Niagara College of Applied Arts and Technology

Parking Lot Reconstruction
Niagara on the Lake Campus
RFP#2019-47

ADDENDUM #4

April 4, 2019

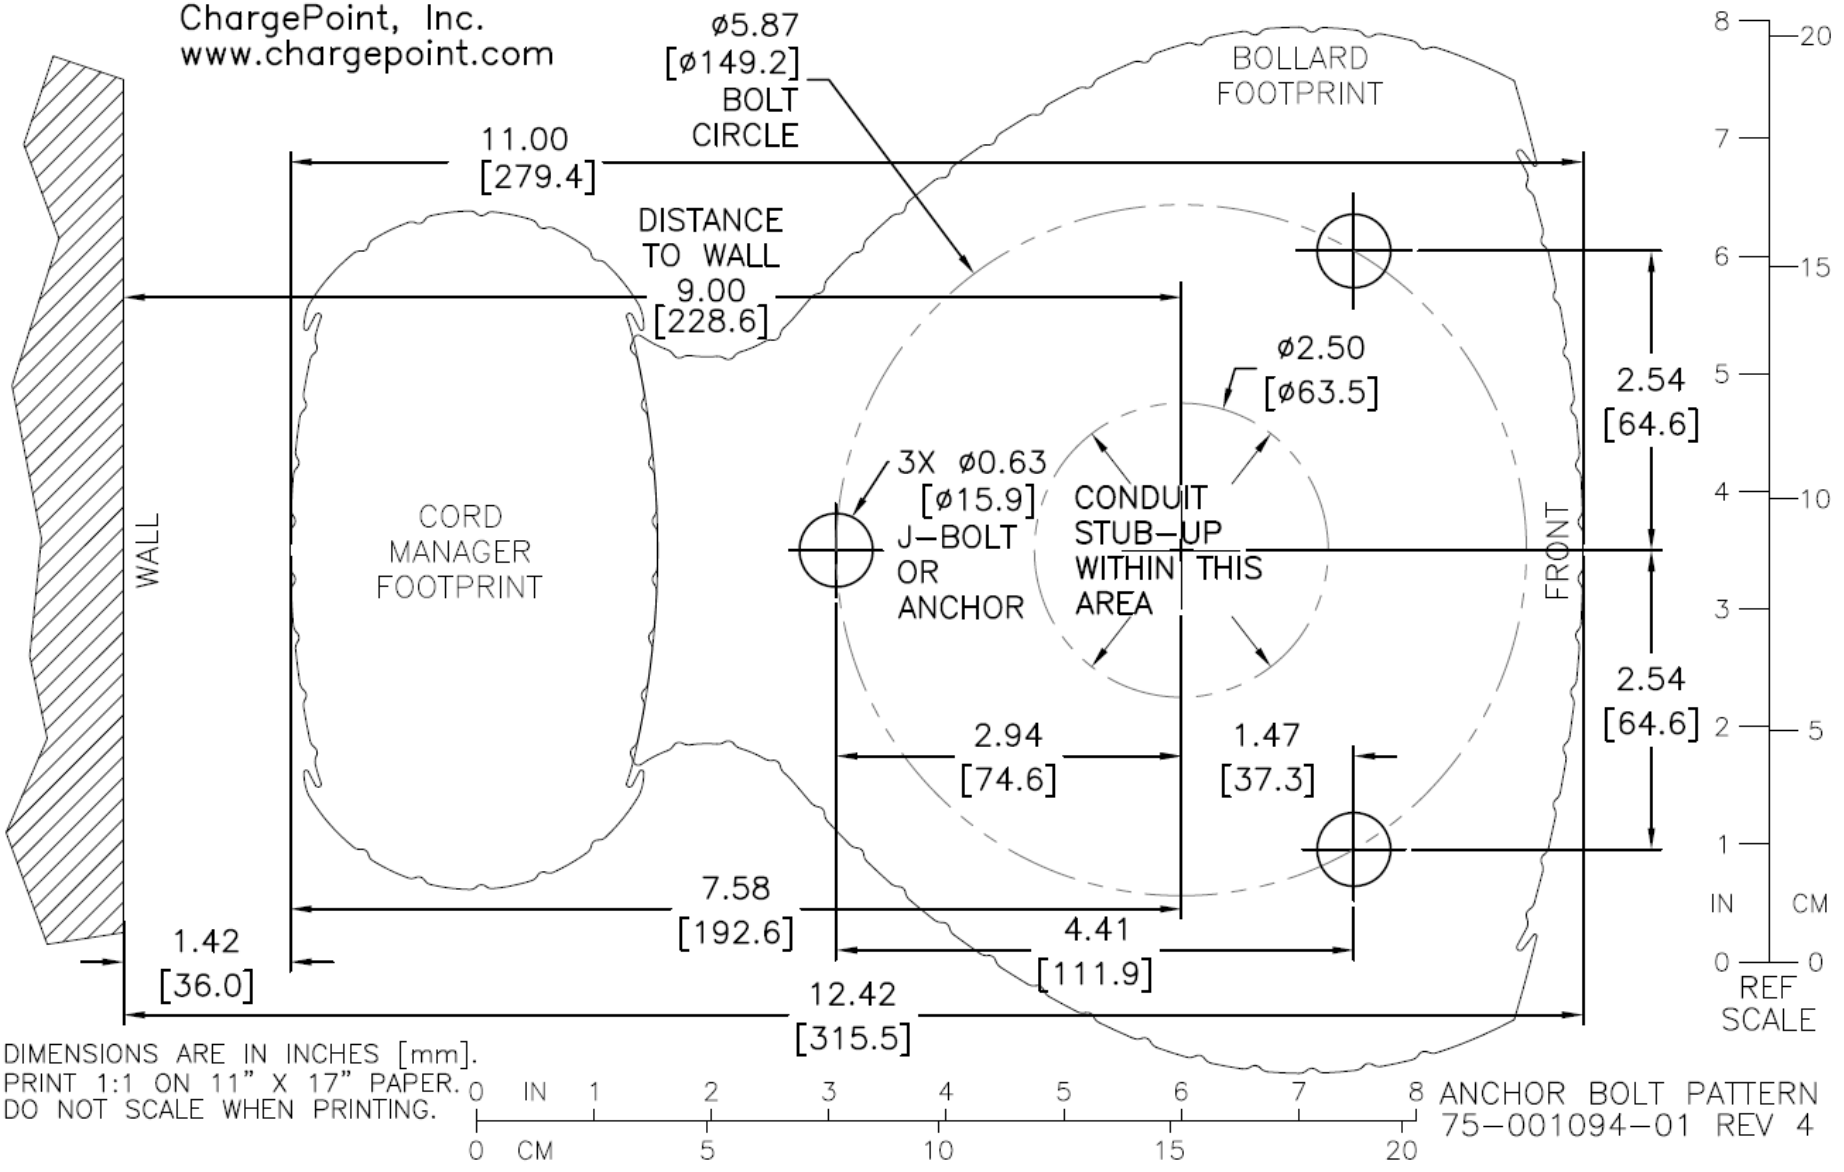
3. **Refer to Revised Appendix 'A' – Item 5.1.11**
   Clarification – This item includes a cast in place concrete base for each unit, 0.6m x 0.6m x 0.6m and mounting with the manufacturers concrete mount kit. The bolt pattern is attached to this addendum.
